**DECLARATION OF TERRY
TOWNSEND IN SUPPORT OF
DEFENDANT RUBY HILL
OWNERS' ASSOCIATION'S
OPPOSITION TO PLAINTIFFS'
MOTION FOR PRELIMINARY
INJUNCTION**

**Reddy Residence
3737 W. Ruby Hill Drive**

**Side-by-side Comparison of
Approved Plans and As-built
Condition**

GAZEBO

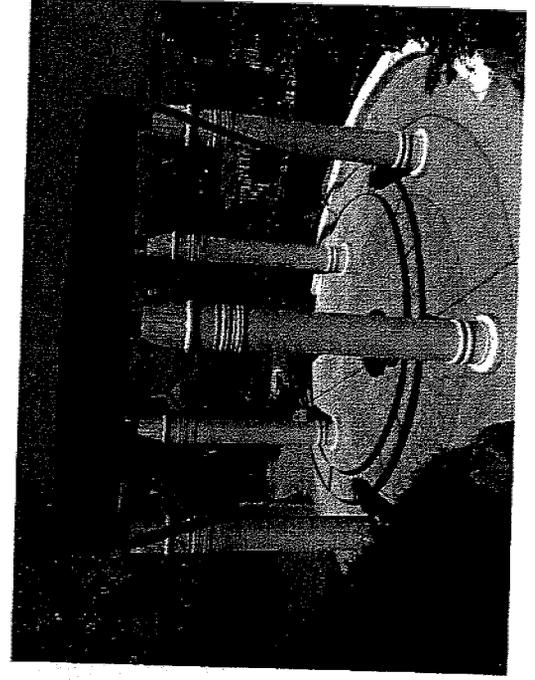
Original gazebo design submitted (8.20.10) – NOT APPROVED

Photo of proposed gazebo submitted to the ADC by Reddy on 4.12.11

- Owner proceeding with construction of gazebo without approval from the ADC or required permits from the City of Pleasanton.
- Original comments from ADC specified that gazebo columns must match final approved columns of the house.
- The iron work submitted in the proposed illustration (4.12.11) was not approved and will not be approved – it is too ornate and is inconsistent with the architectural style of the home.
- The height of the proposed dome exceeds the maximum height limit for a shade structure and accessory structure.

GAZEBO

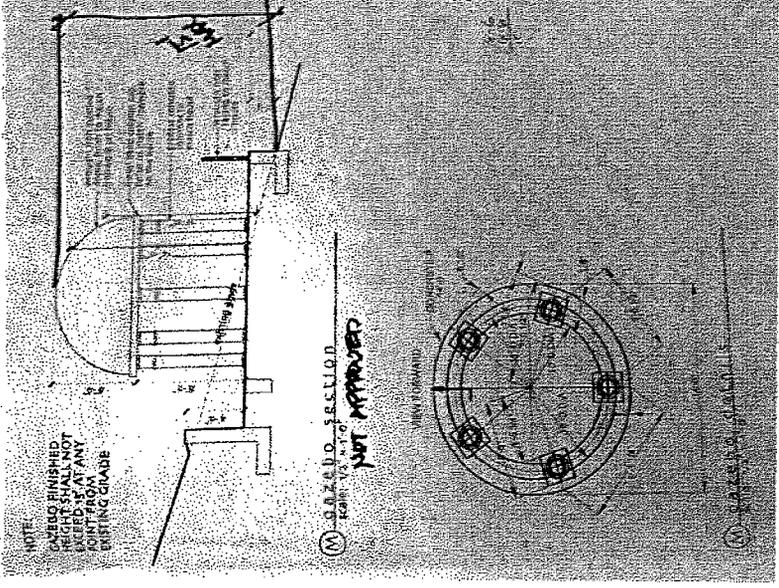
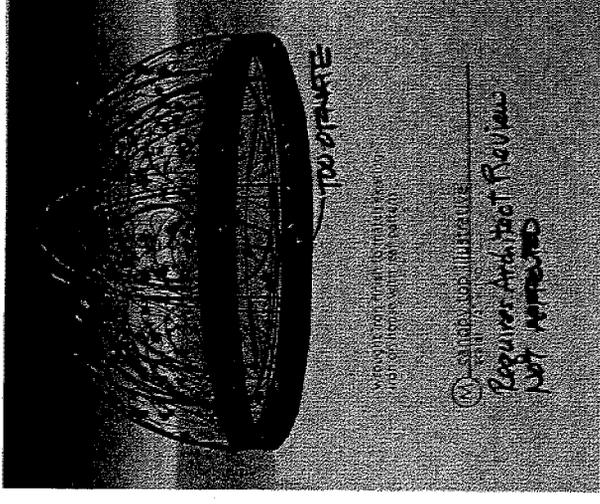
**Gazebo design reviewed
(7.23.12) – NOT APPROVED**

**Gazebo design reviewed
(7.23.12) – NOT APPROVED**
